RHODE ISLAND DEPARTMENT OF TRANSPORTATION

**Bridge Group 53 - Union Village RR**

NOTICE TO PROSPECTIVE BIDDERS

ADDENDUM NO. 3 Prospective bidders and all concerned are hereby notified of the following changes in the Plans, Specifications, Proposal and Distribution of Quantities for this contract. These changes shall be incorporated in the Plans, Specifications, Proposal and Distribution of Quantities, and shall become an integral part of the Contract Documents.

**SIGNING & STRIPING PLAN  
 NO. 2**

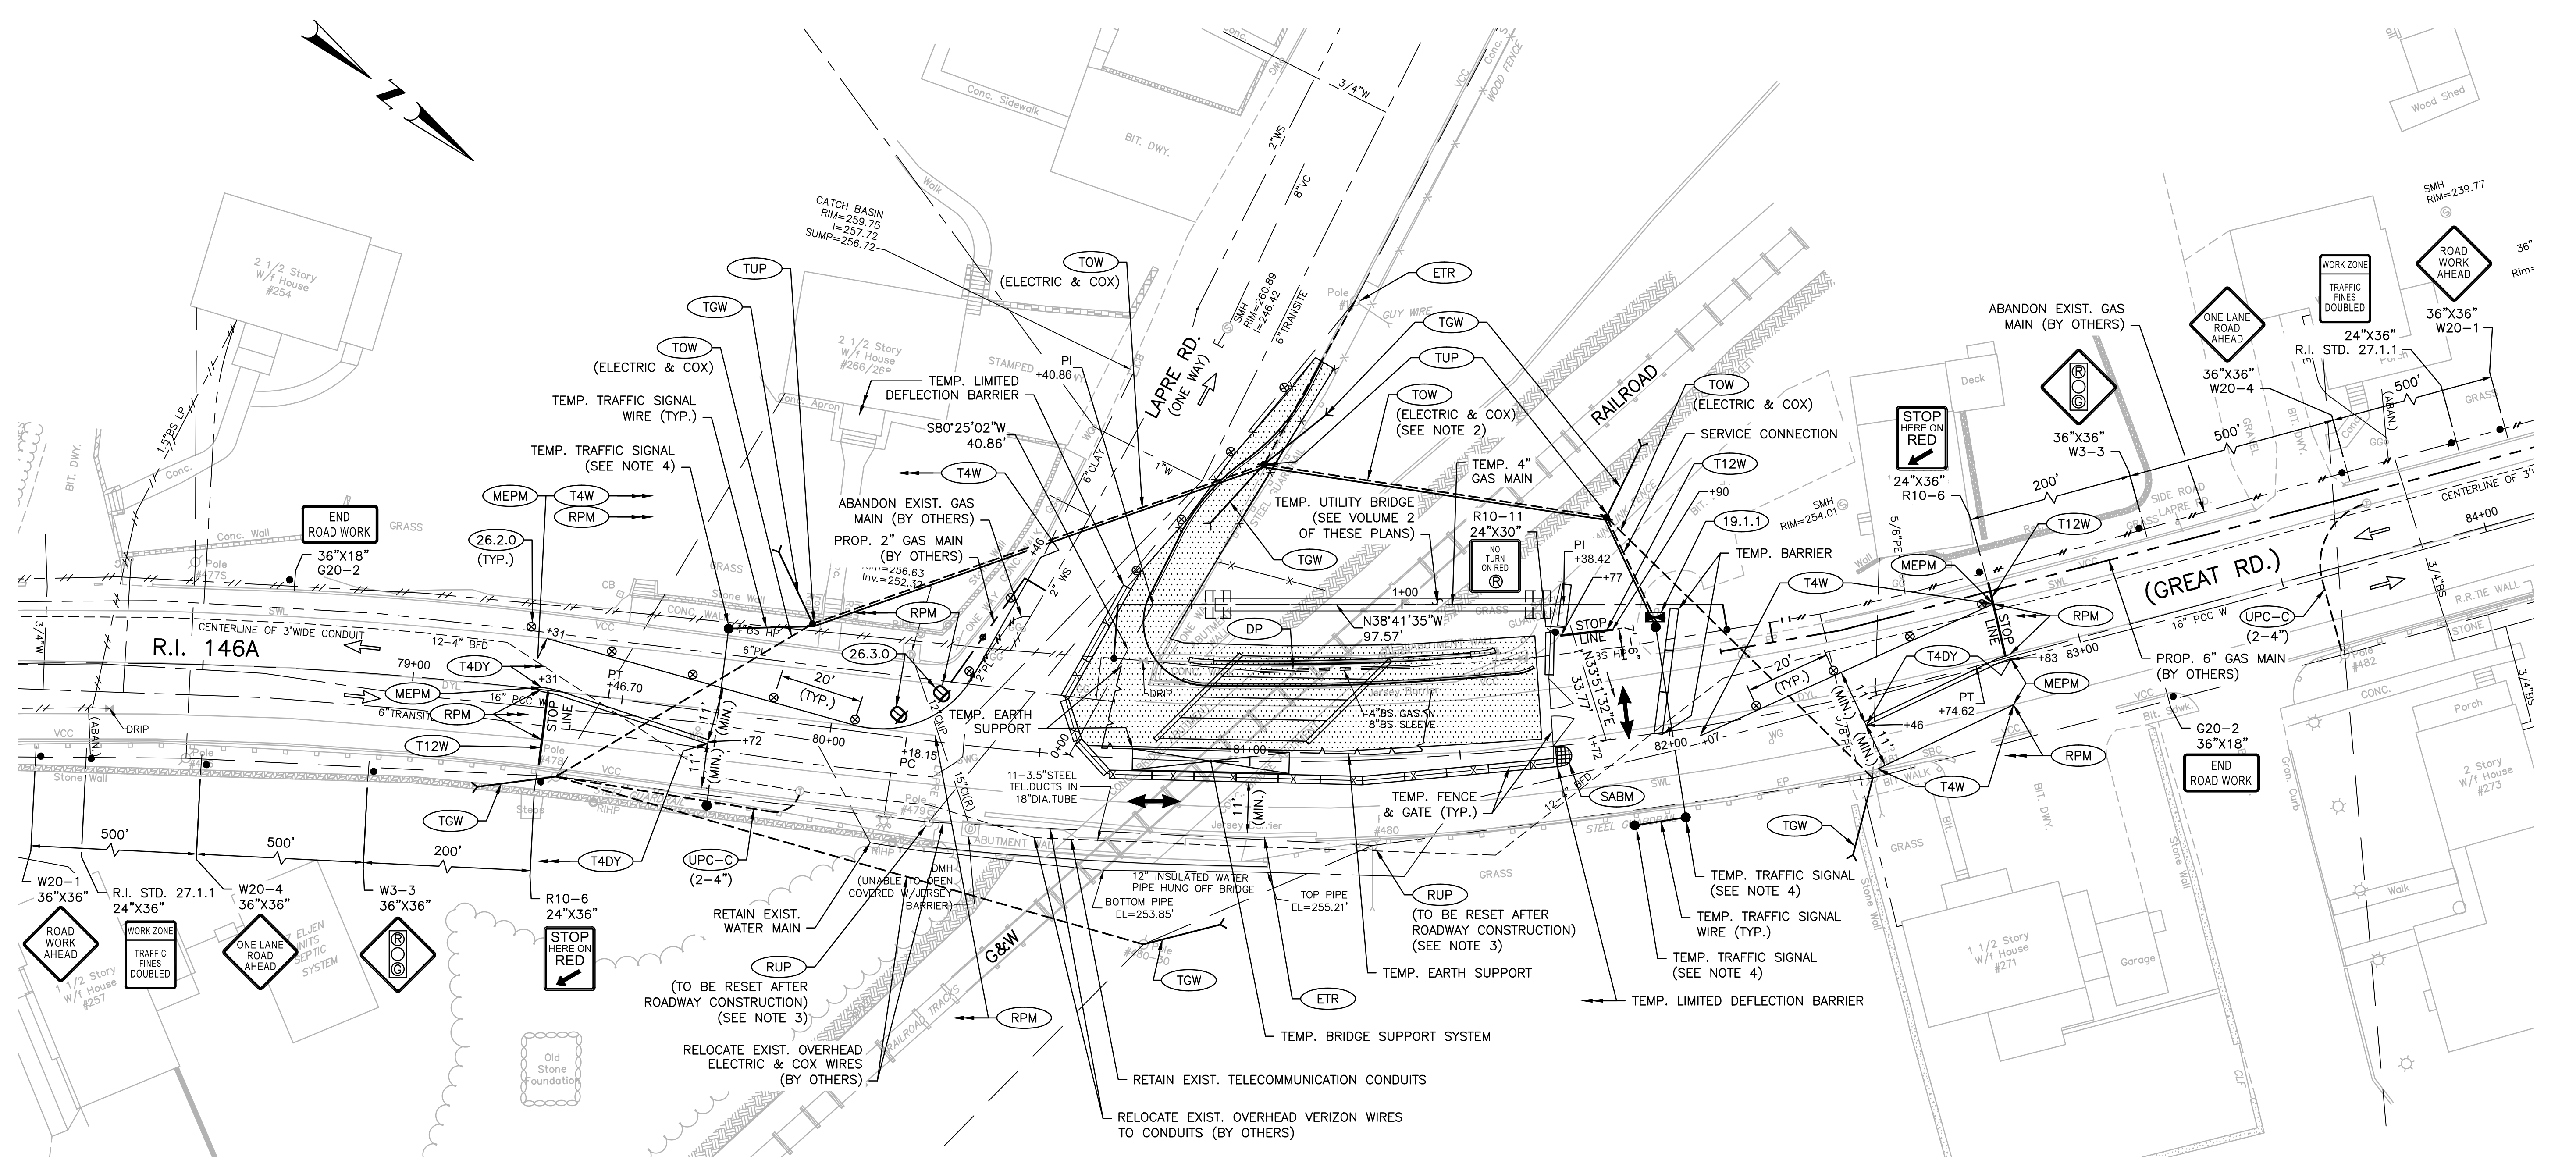
14. VOLUME 1 SHEET 28 - SIGNING & STRIPING PLAN NO. 2  
Remove and replace Sheet 28 in its entirety with revised Sheet 28 (R-1) attached to this Addendum No. 3. Line types have been updated to display correctly based on Sheet 2 revisions.

**MAINTENANCE & PROTECTION  
 OF TRAFFIC PLAN NO. 1**

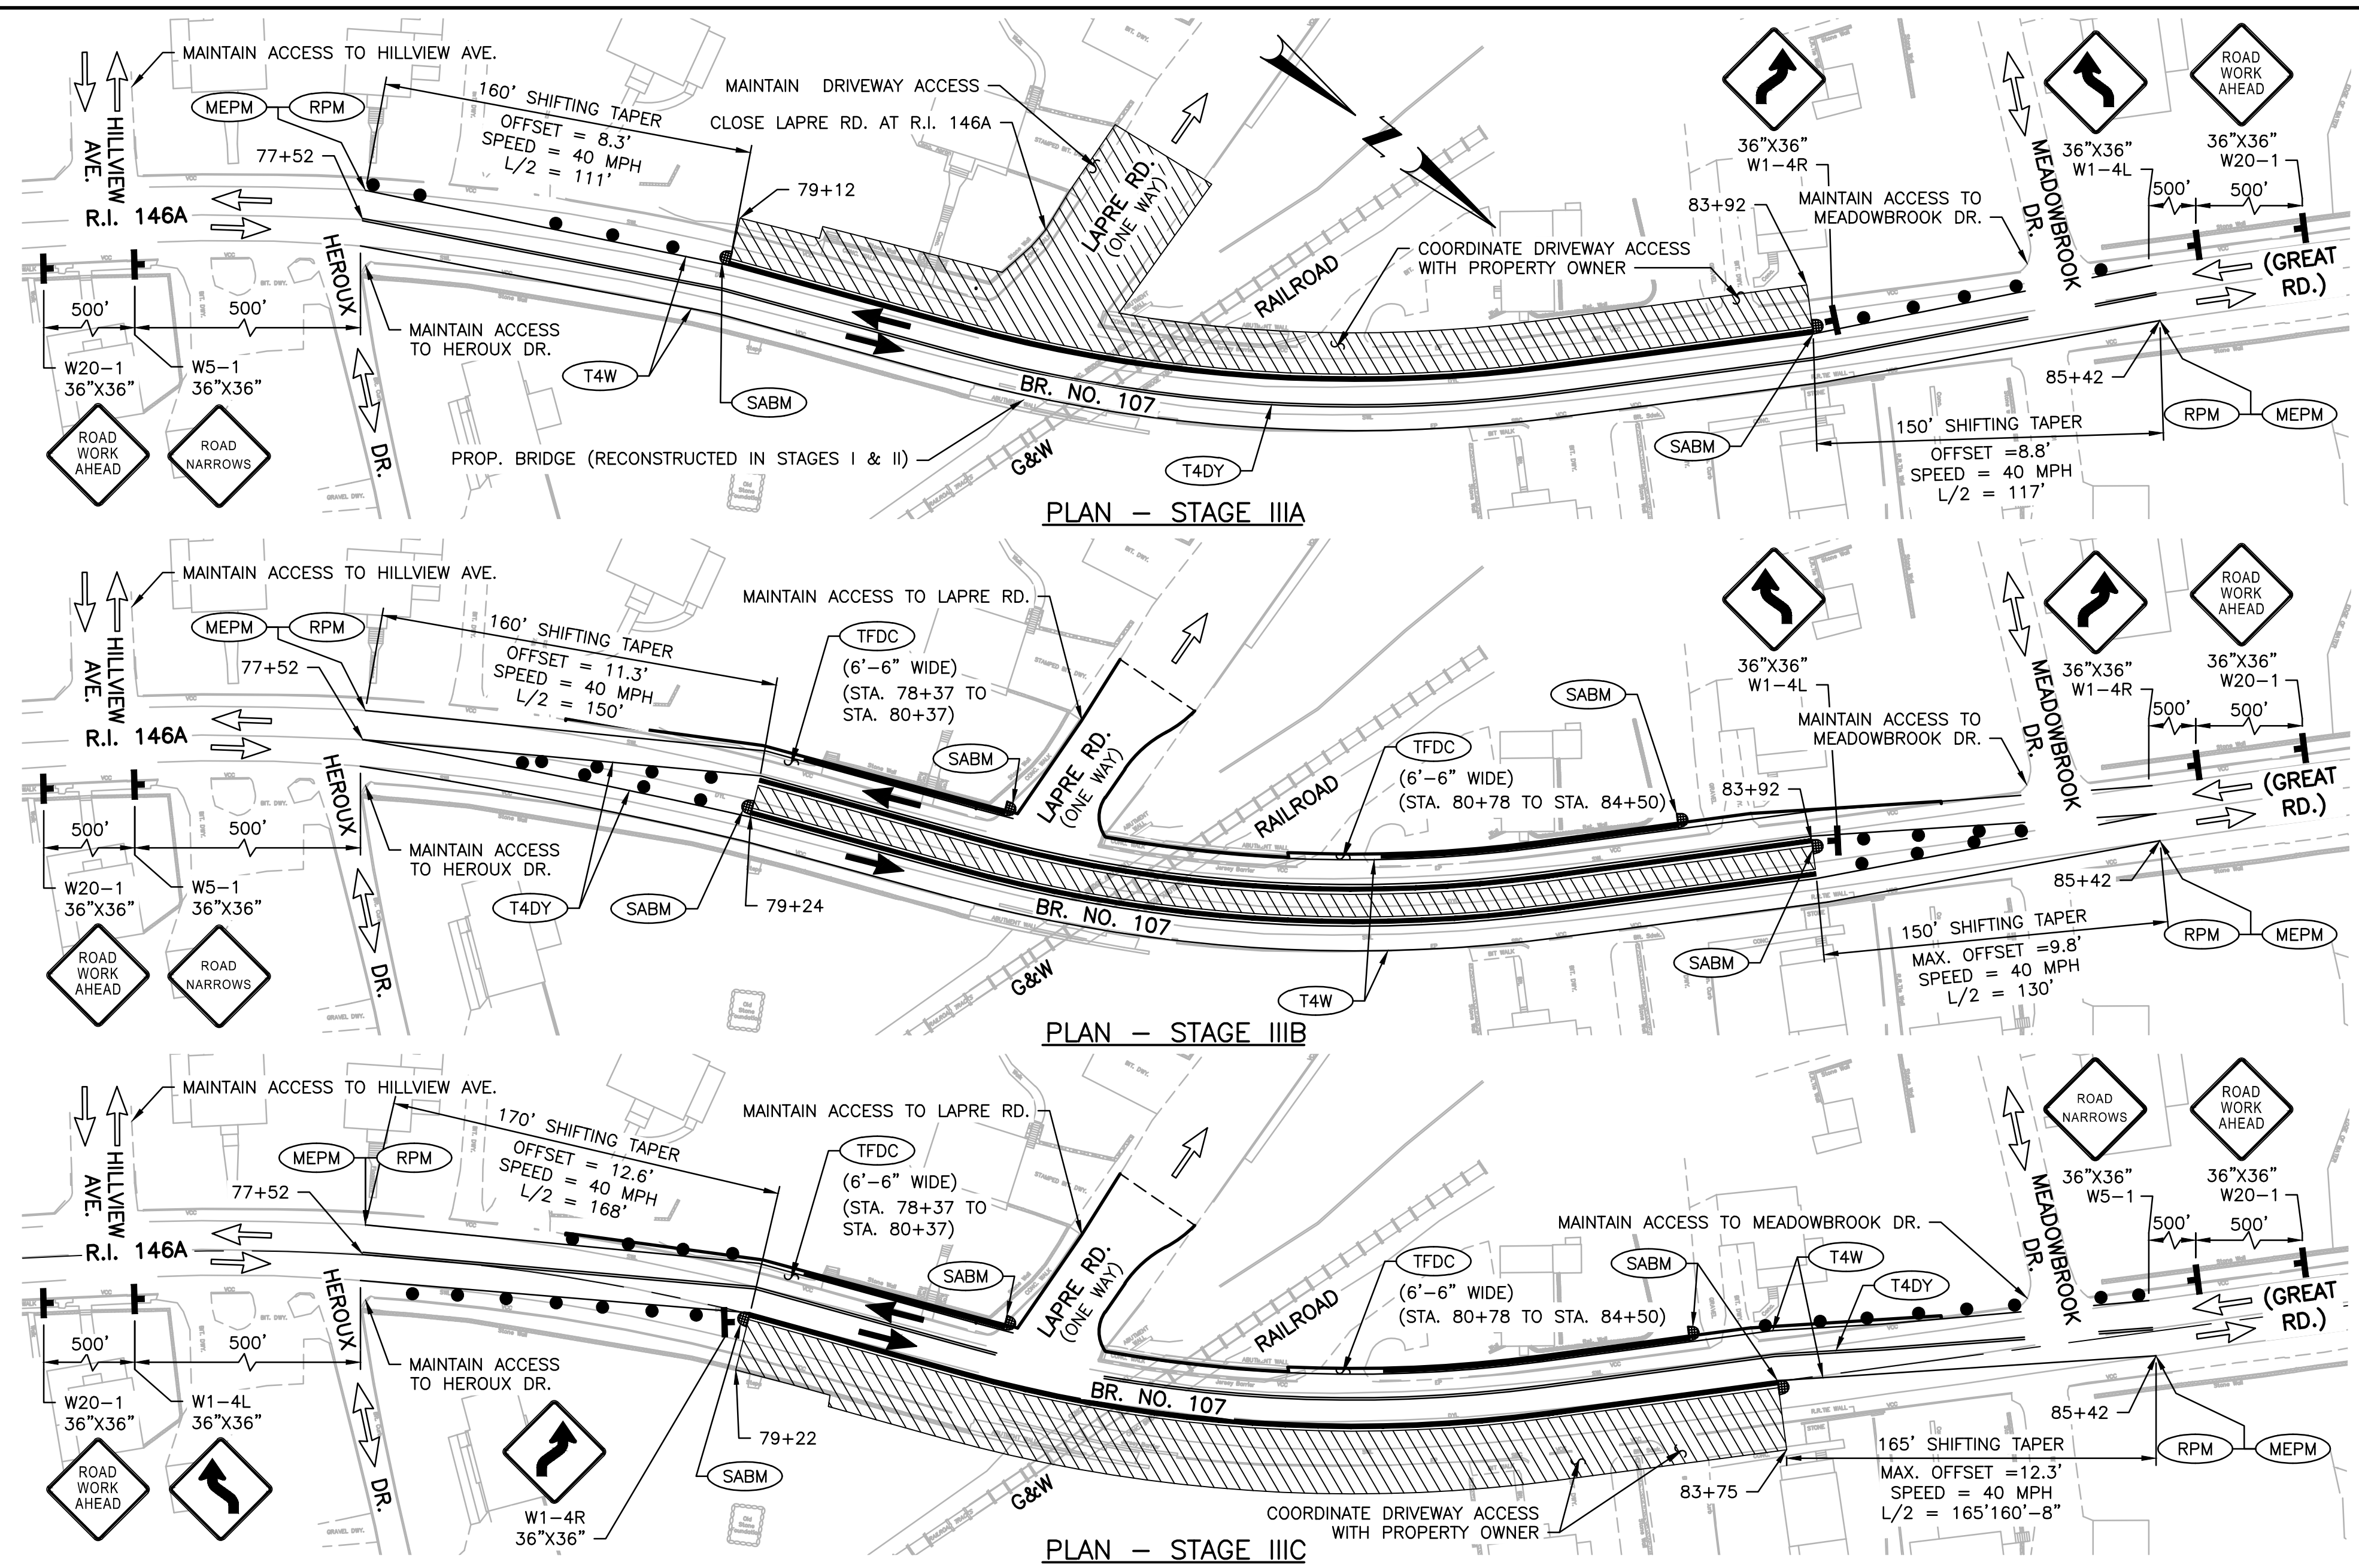
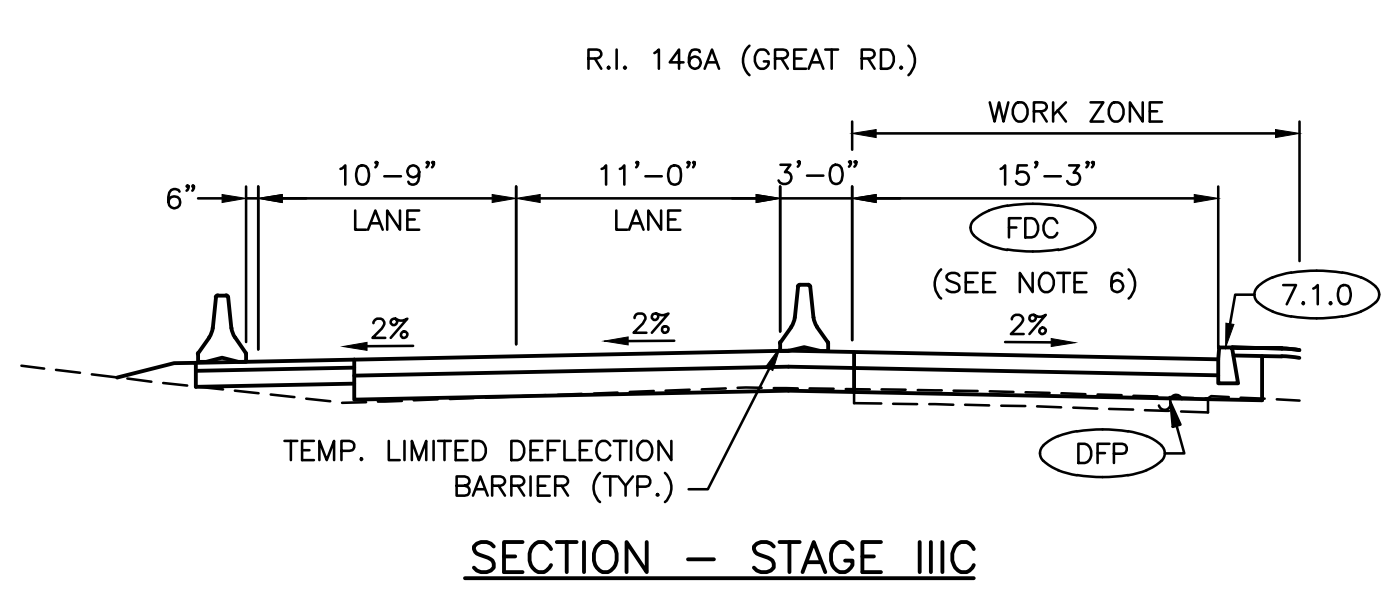
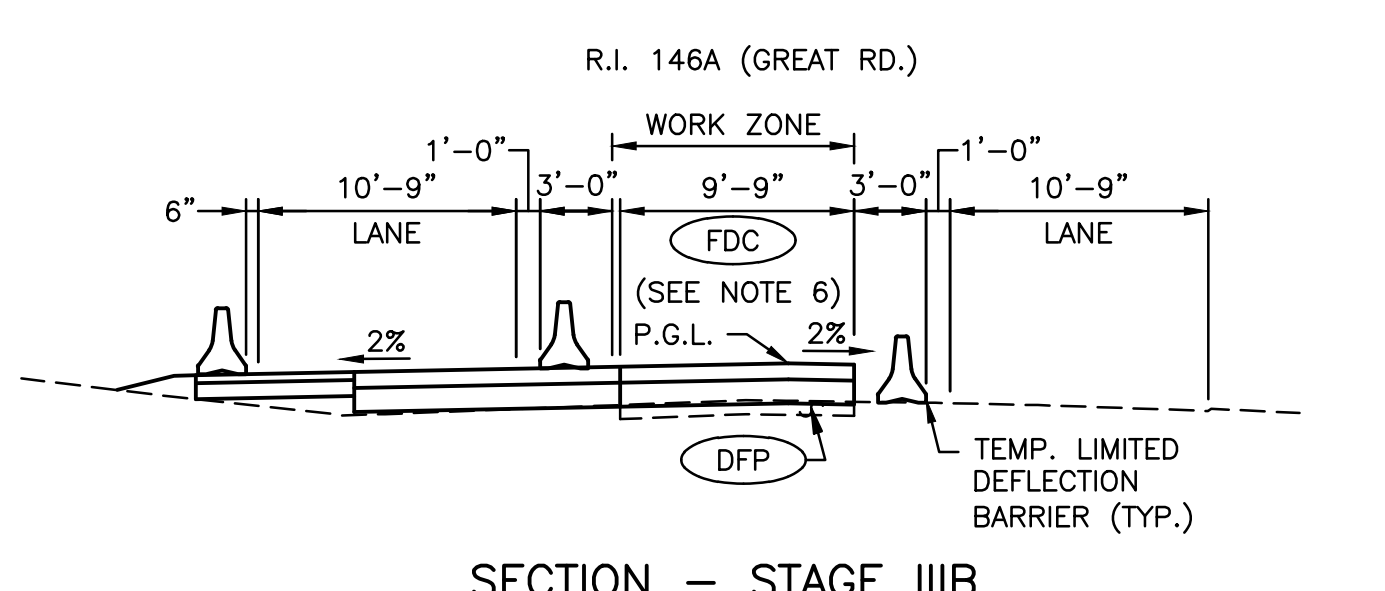
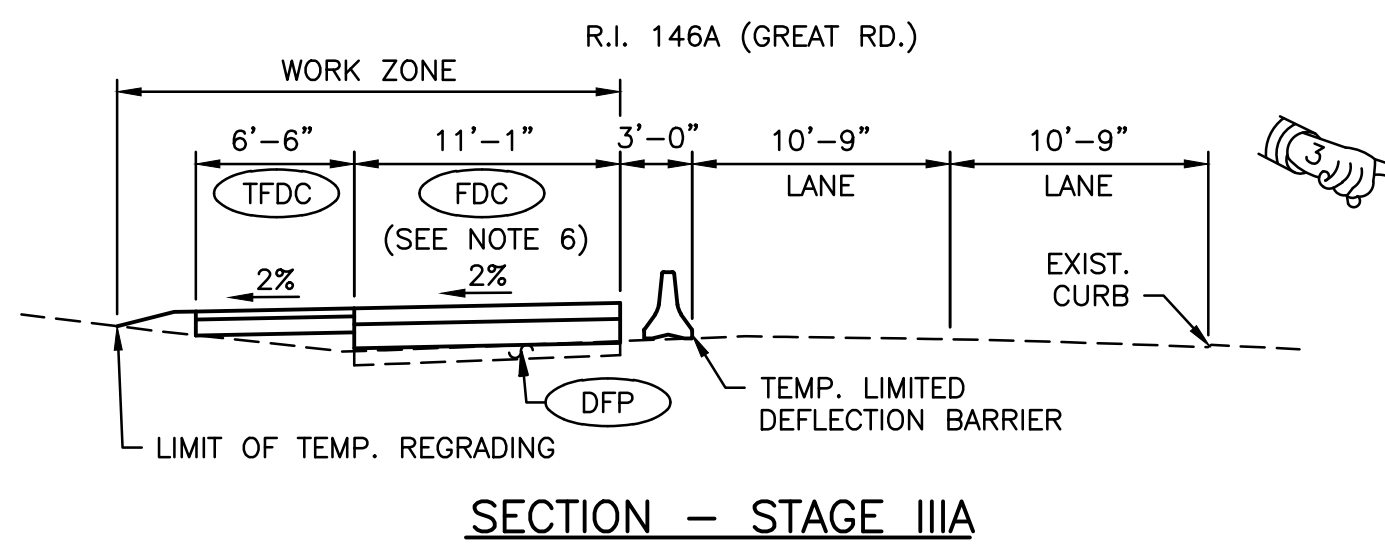
15. VOLUME 1 SHEET 29 - MAINTENANCE & PROTECTION OF TRAFFIC PLAN NO. 1  
Remove and replace Sheet 29 in its entirety with revised Sheet 29 (R-1) attached to this Addendum No. 3. Line types have been updated to display correctly based on Sheet 2 revisions. Additionally, callouts and notes have been updated to clarify the type of temporary barrier.
